May 21, 2015

Re: Class 2 Permit Modification to Install Openings in the Battery Bunker
Containment Building Wall, Buick Resource Recycling Facility (BRRF), 18594
Hwy KK, Boss, Missouri
EPA ID Number MOD059200089

PASTE STORAGE BUNKER-FIGURE 1

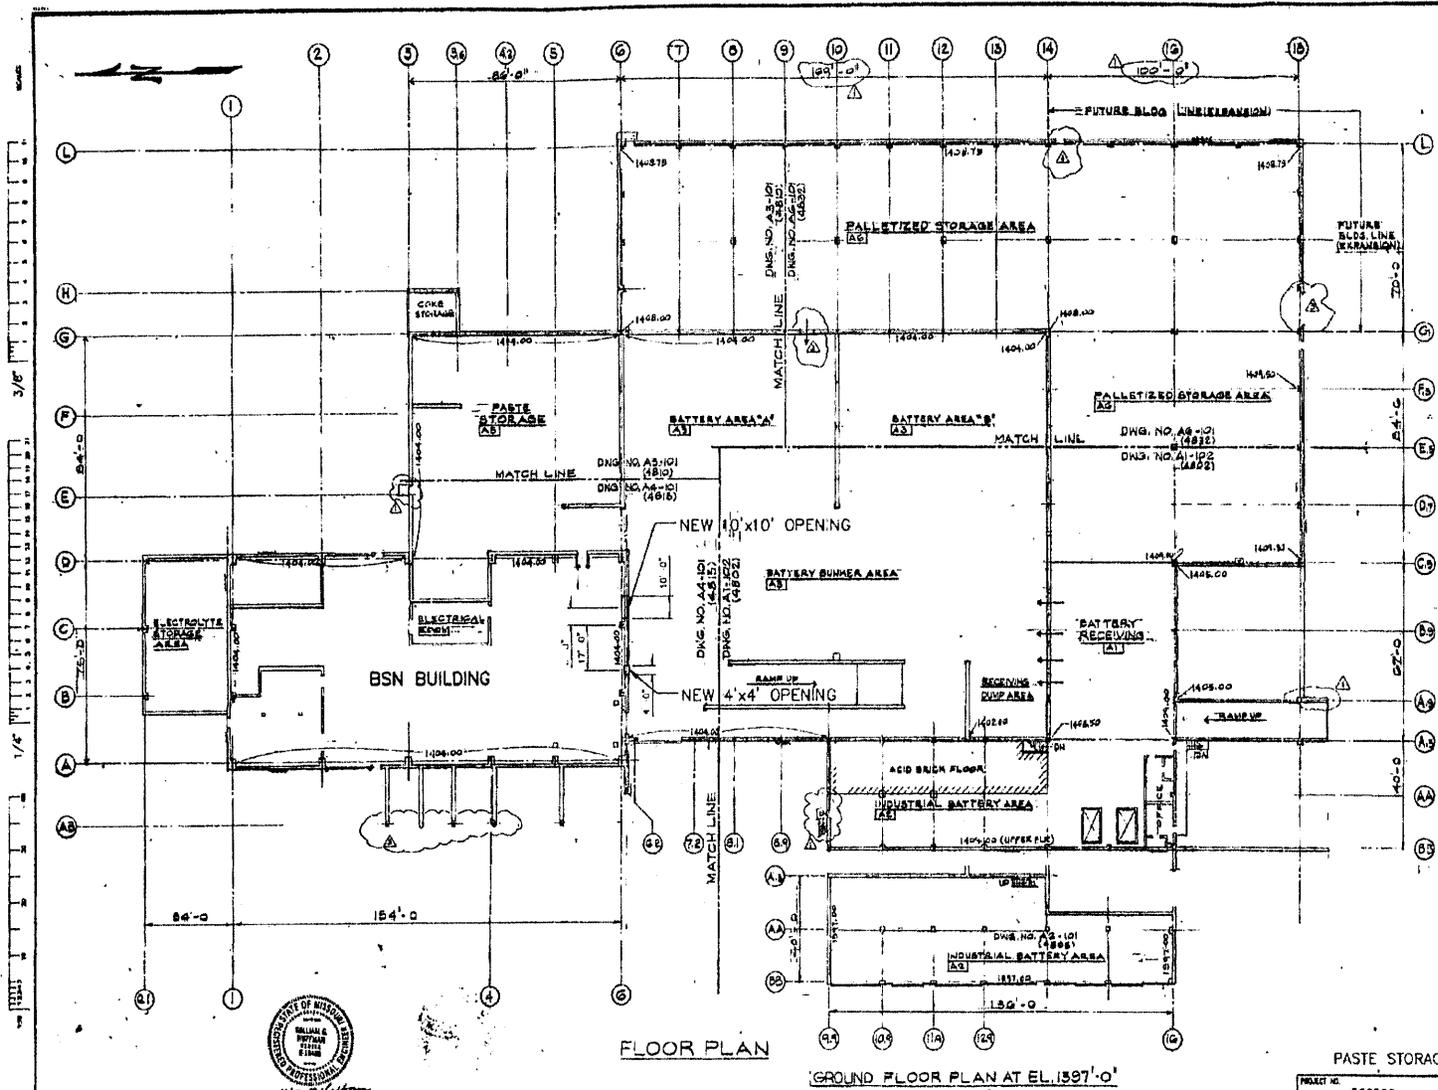
Buick intends to construct two openings in the wall between the Battery Bunker Area (RCRA regulated containment building) and the Breaker, Separation and Neutralization (BSN) Building (see enclosed figure). One opening will be approximately 10-feet wide and 10-feet tall and one will be approximately 4-feet wide and 4-feet tall. These openings will allow easier access to the BSN during housekeeping and maintenance activities.
